3 October 2012

RE: Macarthur Road, Spring Farm – Flood Impact Assessment – Additional Information in response to OEH Letter Dated 24 September 2012 and DoPI enquiries dated 26 September 2012 (transcribed via email from Matt Collins)

Plate 2 – Approximate Stage / Storage Relationship at the subject site

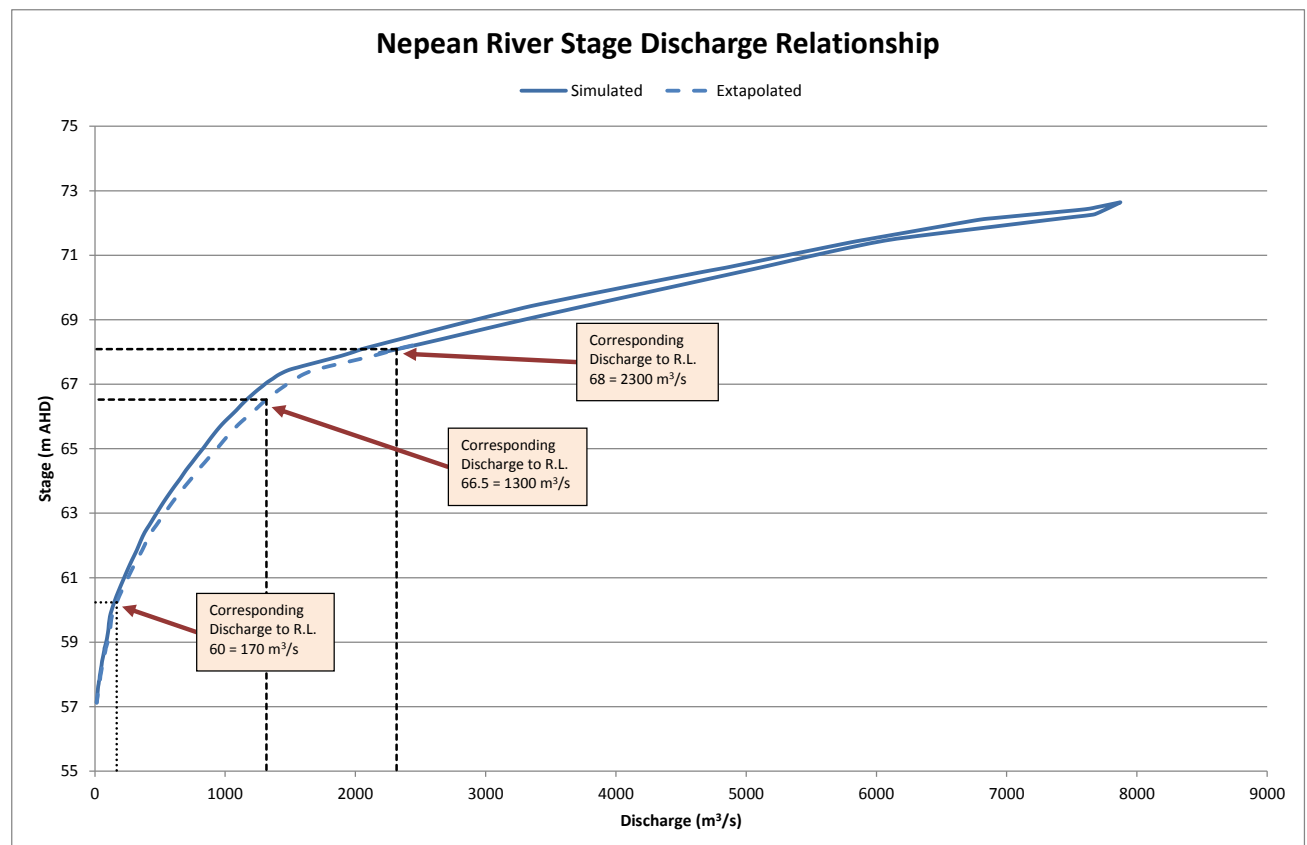
In addition, DoPI has raised some queries relating to internal proposed bunding and the relative frequency of inundation of the lower lying part of the site.

3.3 Predicted ARI at threshold of floodwaters entering the previously mined sites (i.e. Lot 1 and Lot 22)

SMEC estimates that the point at which floodwaters first start to overtop the Nepean river bank on Lots 1 and 22 (i.e. RL 60m, AHD) is less than a 2 year ARI event (say 1 year ARI). The existing Riverbank within Lot 32 (e.g. RL 65.0m, AHD) would have a level of protection of approximately the 2 year ARI.

Using Data derived from the TUFLOW model output, and compared to an approximate flood frequency analysis for the Cowpasture Bridge Flood Warning Gauge just downstream of the site, SMEC have been able to approximate the ARI for various stage levels within the subject site. Note this is very approximate only. **Plate 2** above outlines the relationship derived.

Based on this relationship, the processing area of the site, which is located adjacent to Macarthur Road in Lot 1 has a natural ground level of approximately RL 68.0m, AHD, however, floodwater would first enter this area at, say RL 66.5m, AHD. This part of the site would begin to be inundated in events of an ARI of approximately 3 year ARI, but would not significantly be inundated until a 6 year ARI event (i.e. RL 68m, AHD). **Figure 6** shows approximate location of ground surface levels referred to in this report.

Figure 1 - 20 Year Flood Level Difference

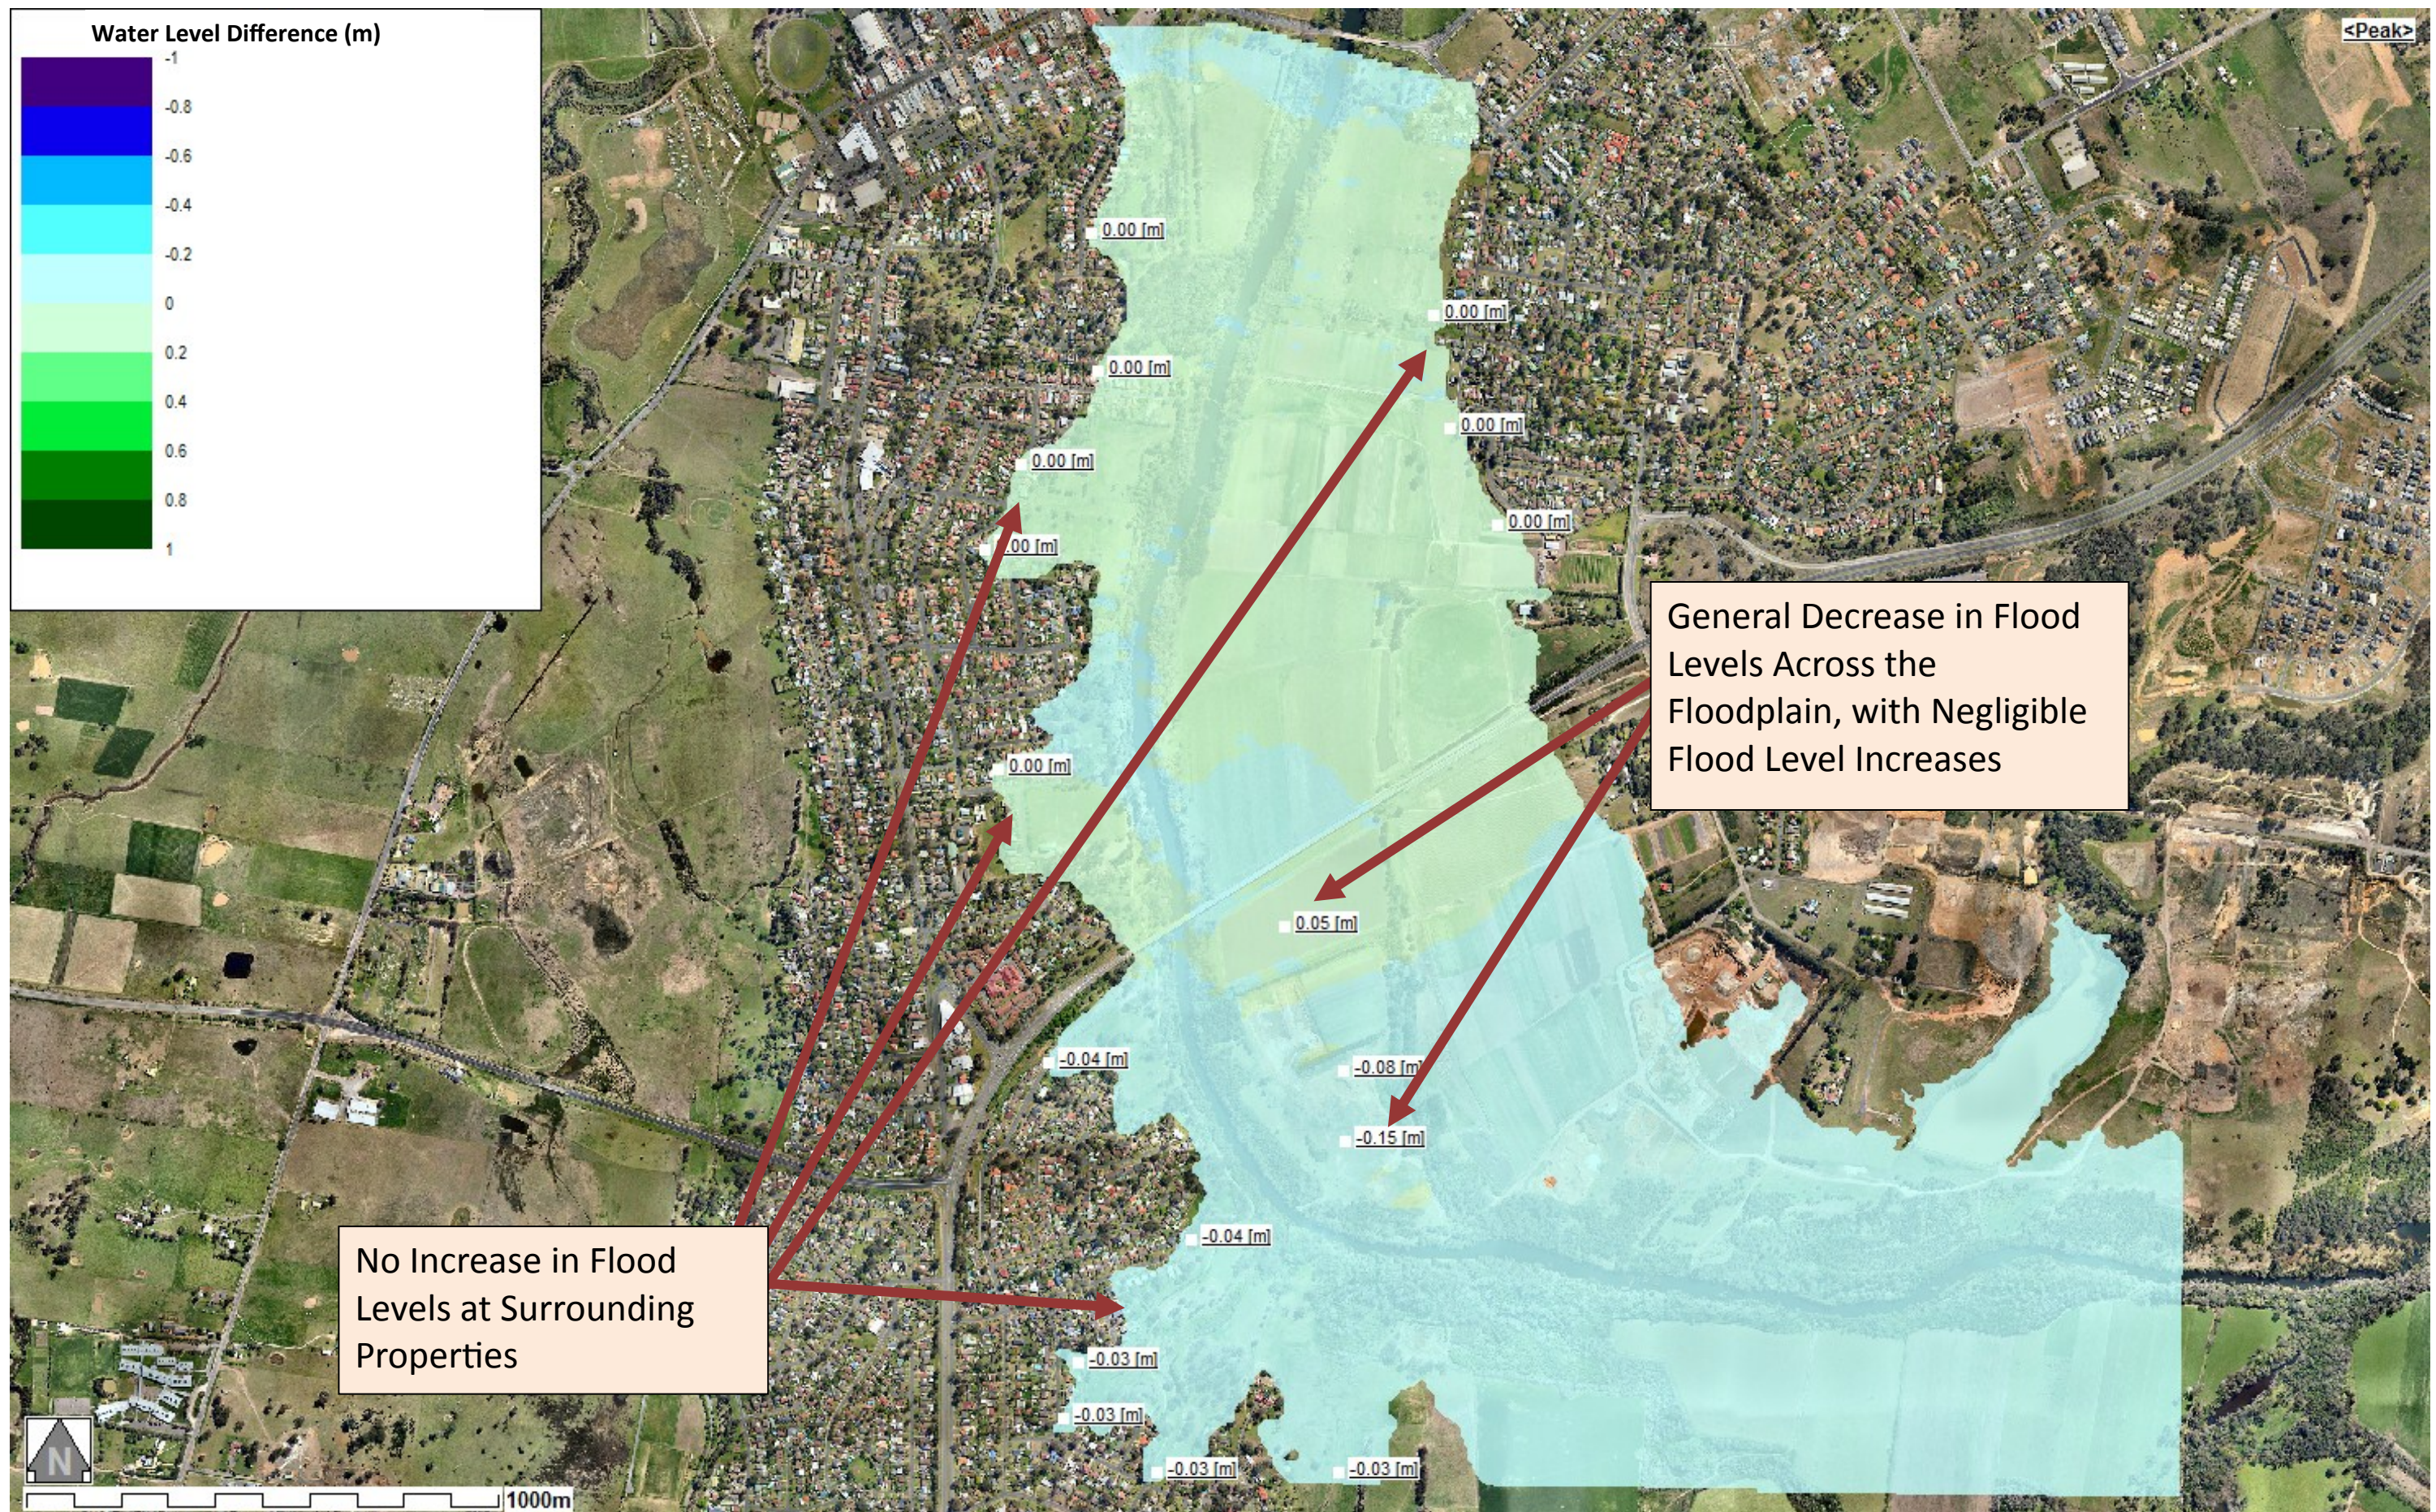
DoPI appear to have misunderstood our previous report. The water surface level difference between the site and the river is a natural occurrence. As flood waters recede from the floodplain there is a natural tendency for the River levels to drop faster than the levels on the floodplain, and hence the reason why there is approximately 0.5m of water level difference between the floodplain and the river. This is not as a result of the development, nor is it caused by the proposed excavation, this is a natural phenomenon, by way of example the water level in the bottom of a sink that is draining being slightly lower than the water level at the edge of the sink, as the sink drains.

SMEC have assessed the potential impact of flood levels as a result of the development, and generally there is no predicted increase in flood level in events up to a 100 year ARI event, other than very localised effects – in fact, there will be a decrease in flood levels, as shown attached for the differences between existing and proposed case peak flood level for the 20 year ARI - refer **Figure 1** and 100 year ARI difference plots shown in **Figure2**.

As can be seen in these Figures, generally there is no predicted significant increase in flood levels anywhere in these events, rather there is an estimated decrease in peak flood level at the subject site.
